Valero Pembrokeshire Oil Terminal Permit Variation Decision Document

Application for a Normal Variation

The application number is: PAN-026226

The permit variation number is: EPR/BK1341IN/V008

Figure 1: location and containment measure for the tanks from the document: “SemLogistics Milford Haven – Review of Refining Mineral Oil and Gas BAT Conclusions”, 2015 (submitted as part of the Regulation 61(1) response)

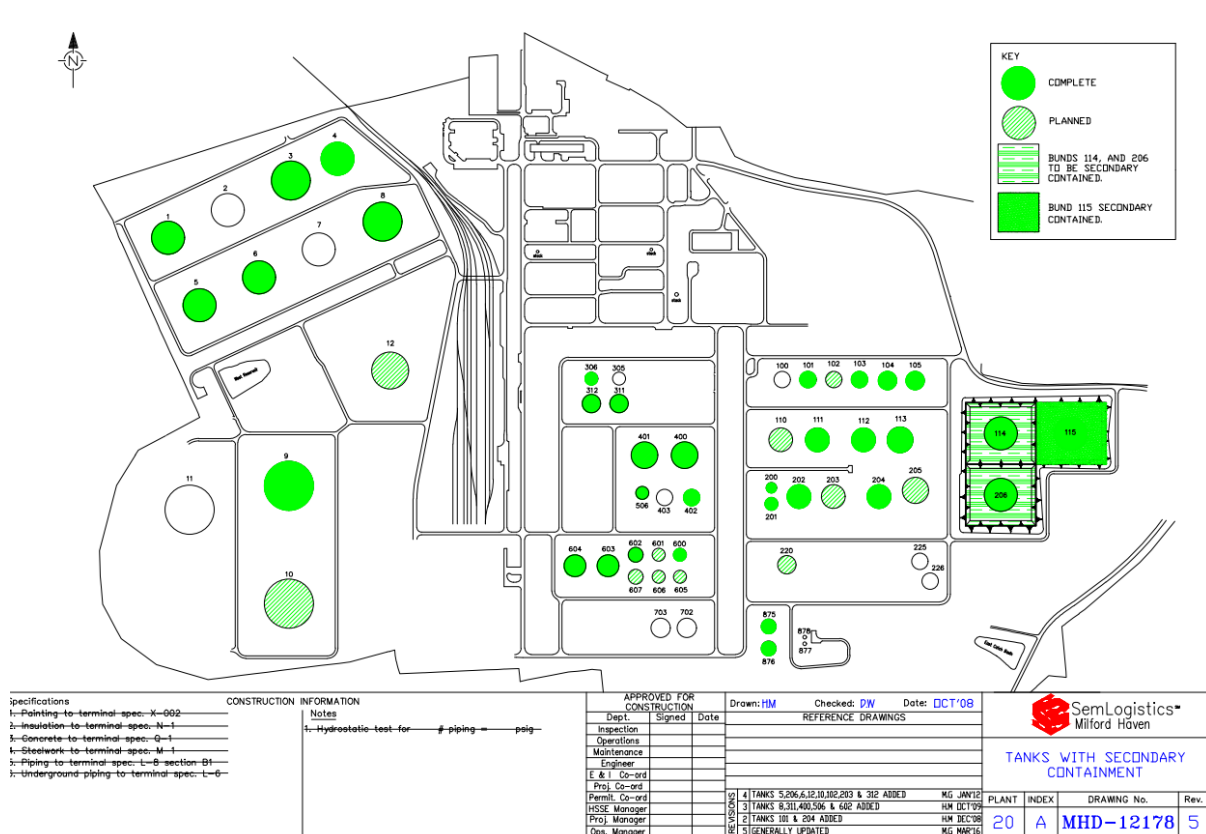
Tanks 875 and 876 are located next to the effluent treatment plant (see figure 1). The effluent (oily water) generated from the storage of the crude (in tanks 9, 11 and 12) will be pumped to tanks 875 and 876 for settlement prior to treatment at the effluent treatment plant (where recovered oil is sent back to tanks 875 and 876). The treated effluent is discharged via emission point C. Oil recovered from the settlement would be sent to Pembroke Refinery for further processing.

The crude that is to be accepted on site (before being sent to the Pembroke Refinery) is to be stored in three tanks (tanks 9, 11 and 12) which are located on the western edge of the site. All three tanks have secondary containment in the form of an earth bund but the bunds for all three tanks are unlined. Tank 11 has no under tank liner, whilst tanks 9 and 12 do have under tank liners.

Given that the bunds were unlined and tank 11 does not have an under tank liner, there was a potential risk to ground posed by the tanks in the event that a loss from

primary containment failure occurs. However, these tanks are already permitted for the storage of crude oil under the current permit and had in the past stored crude when the site operated as a refinery. The variation while allowing the crude to be sent to Pembroke refinery, will not change the permitted storage of crude and the theoretical risk posed by the permitted operations after the variation would not increase compared to the risk from existing activities authorised on site.

BAT conclusion 51 of the Best Available Techniques for the Refining of Mineral Oil and Gas (2015) is to prevent or reduce emissions to soil and groundwater from the storage of hydrocarbon compounds, using one or more of the suggested techniques. As part of the schedule 5 response the operator had outlined how they apply techniques against BAT 51. Tanks 9, 11 and 12 fall within the scope of the COMAH containment policy. These have already been assessed under COMAH and we are expecting the submission of the Operator's COMAH improvement plan in 2026. The requirements of the COMAH containment policy, go beyond those of BATc 51 to demonstrate BAT. The Operator will be required to make any required improvements in line with the improvement plan and outcome of ongoing COMAH inspections.

Permit condition 3.2.1 requires that emissions of substances not controlled by emission limits (i.e., fugitive emissions) shall not cause pollution. Permit condition 3.2.3 requires that all liquids in containers, whose emission to water or land could cause pollution, shall be provided with secondary containment, unless the operator has used other appropriate measures to prevent or where that is not practicable, to minimise, leakage and spillage from the primary container. These conditions are enforceable and we will take appropriate action if they are not complied with.
